**TAKACHI ELECTRONICS ENCLOSURE CO., LTD.**

## **NOTICE**

### **BMP-P series Plastic Mounting Plate Changes to Dimensions and Shape**

BMP3040P

Details of the changed points.

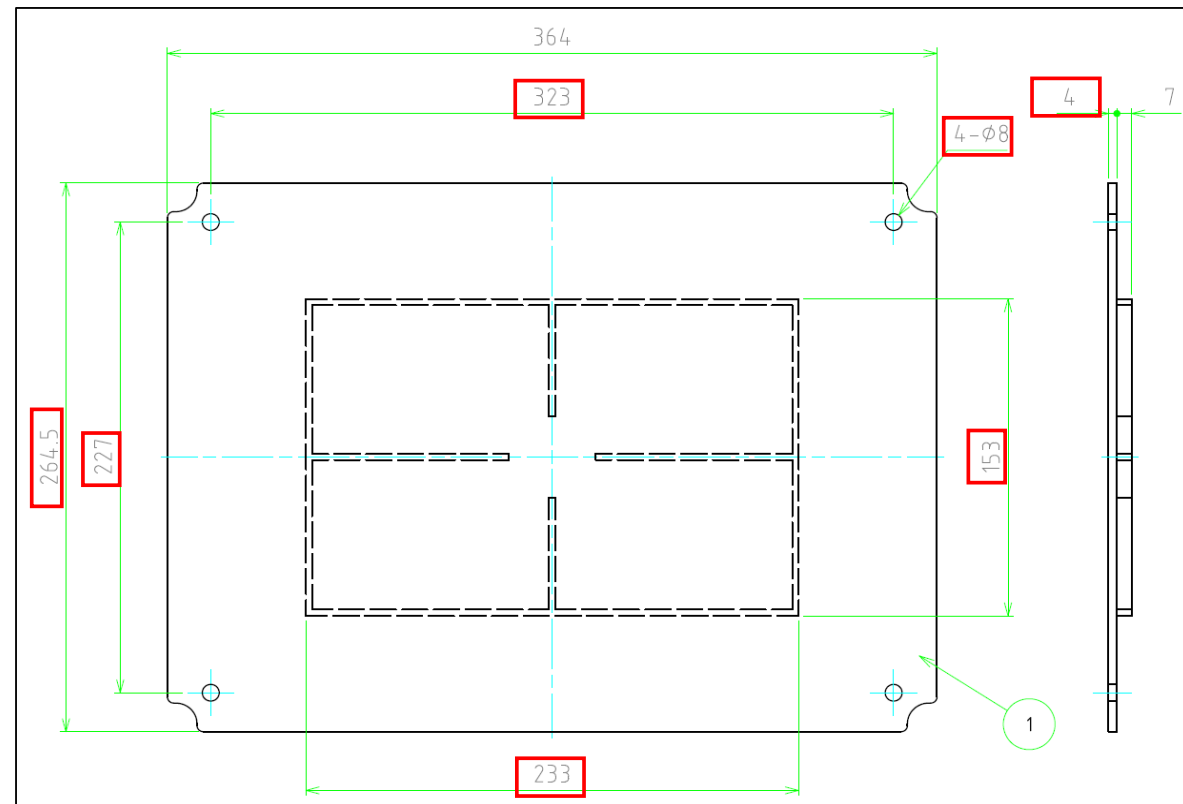
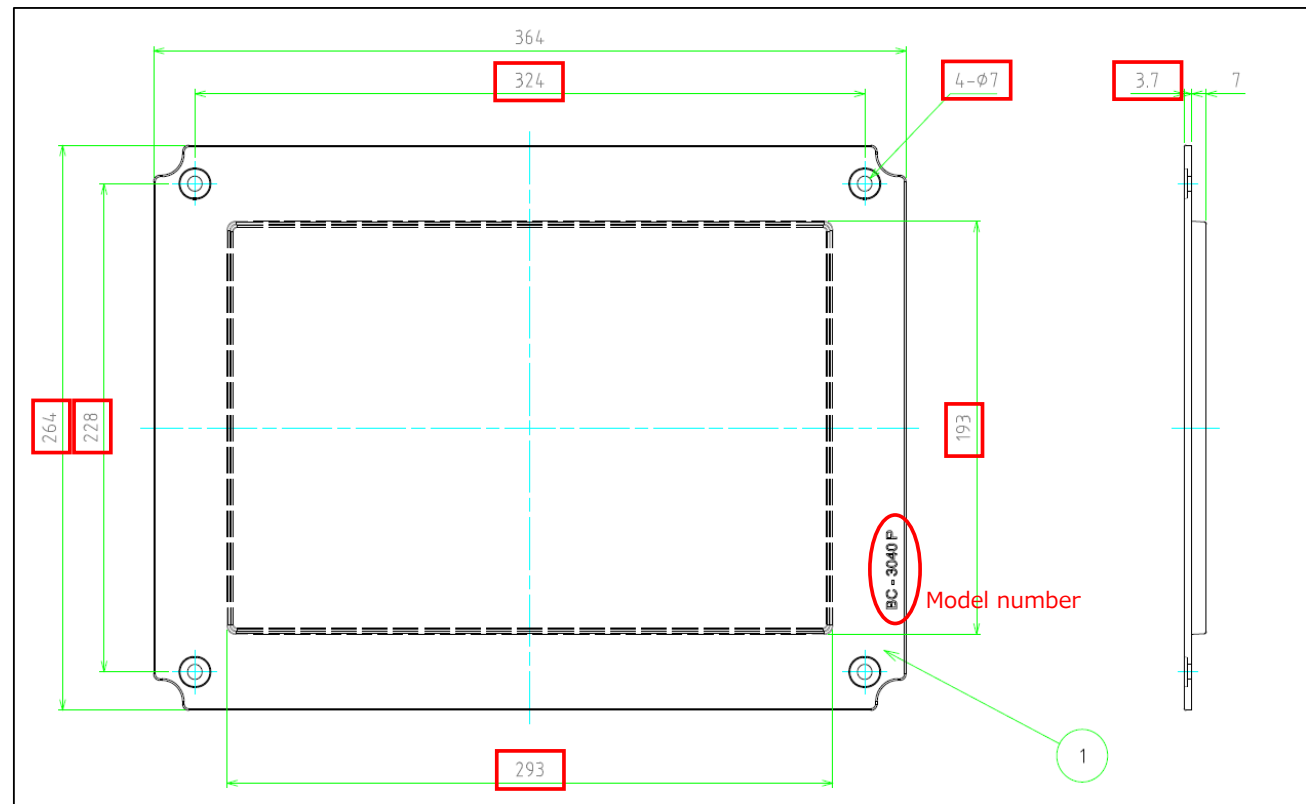
■ Change : Dimensions and Shape (see separate sheet for the details).

Old Dimensions

New Dimensions

Old Design and Shape

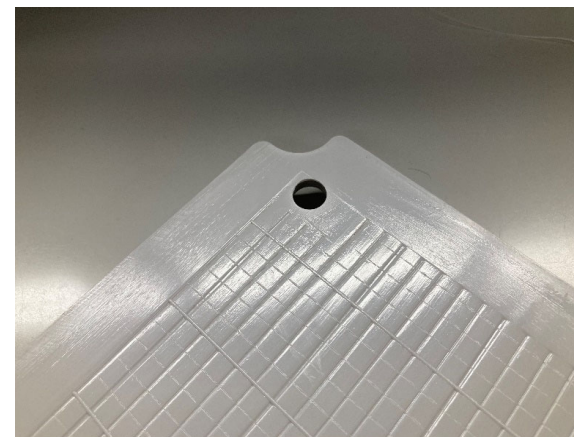
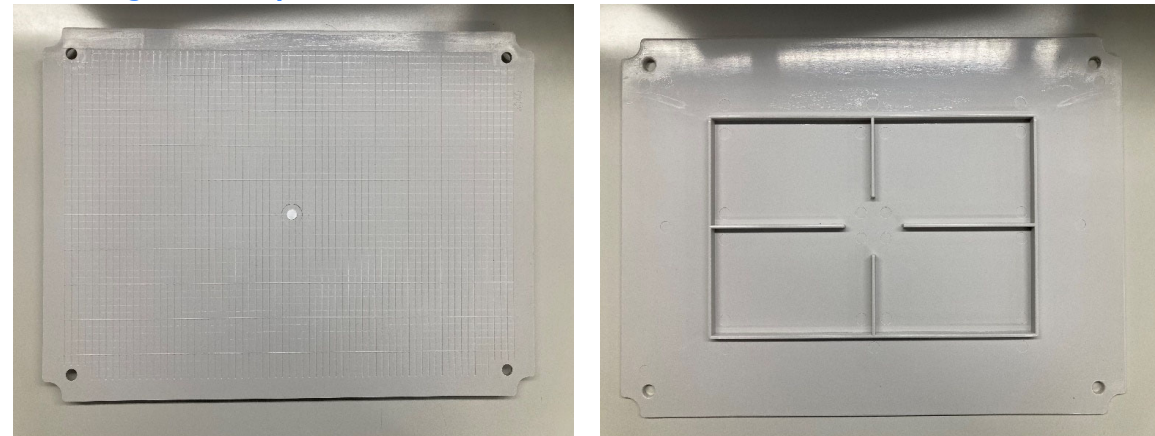
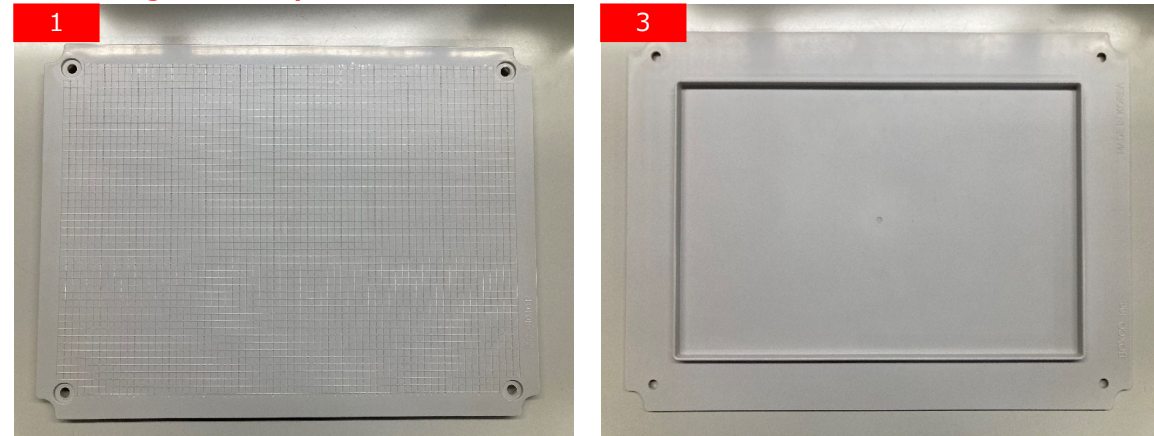
- 1** Injection gate moved to back side.
- 2** Changed to Counterbored shaped holes.
- 3** Size and shape of the rib on back side are changed.
